**From:** noreply@feedback.planningportal.nsw.gov.au  
<noreply@feedback.planningportal.nsw.gov.au>  
**Sent:** Tuesday, 17 December 2019 6:13 PM  
**To:** DPE PS ePlanning Exhibitions Mailbox <eplanning.exhibitions@planning.nsw.gov.au>  
**Subject:** Webform submission from: Mamre Road Precinct in the Western Sydney Employment Area

Submission: To Whom it May Concern, In reference to the indicative riparian buffers on the draft structural plan, we have engaged with Eco Logical Australia to provide an assessment of the riparian land and waterways of our property at 113-127 Aldington Rd, Kemps Creek, 2178. In conclusion, it is ELA's opinion that the watercourse within the study area does not meet the definition of a 'river' under the WM Act 2000, as there was no defined bed and banks in the areas where the mapped watercourse was located on your draft plan. Therefore we lodge this submission in opposition to the location of the riparian buffer on our property. Please see attached report in support of the submission for further information.

# 113 - 127 Aldington Road, Kemps Creek - Riparian Constraints Assessment

Figure 2: Mamre Road Precinct environmental considerations map (DPIE, 2019). Red indicates study area

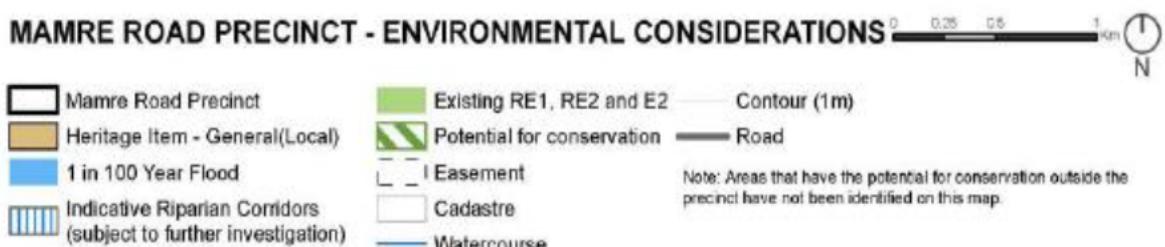
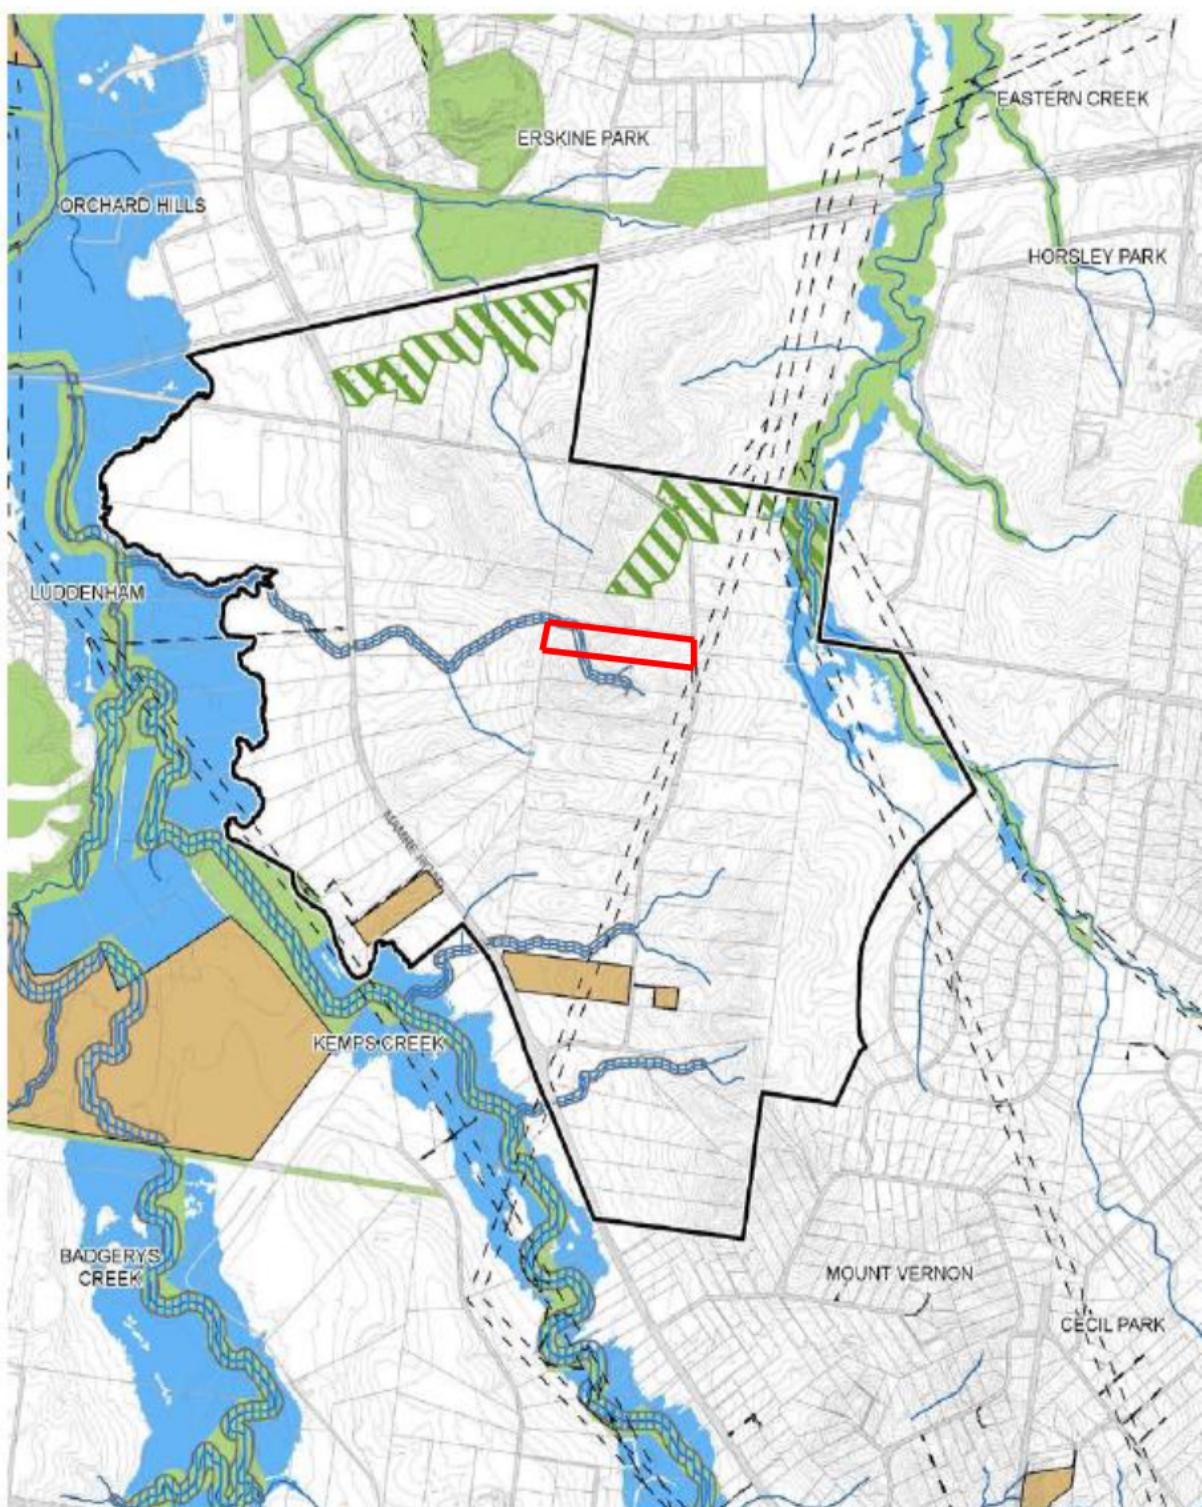
The Discussion Paper outlines the existing conditions within the Mamre Road Precinct, including existing areas of riparian land and high biodiversity value (Figure 2). This figure, as well as the Structure Plan (Figure 3), both map the study area as a potential riparian corridor. This assessment was therefore undertaken to determine if the mapped watercourse within the study area met the definition of a 'river' in accordance with the *Water Management Act 2000* (WM Act).
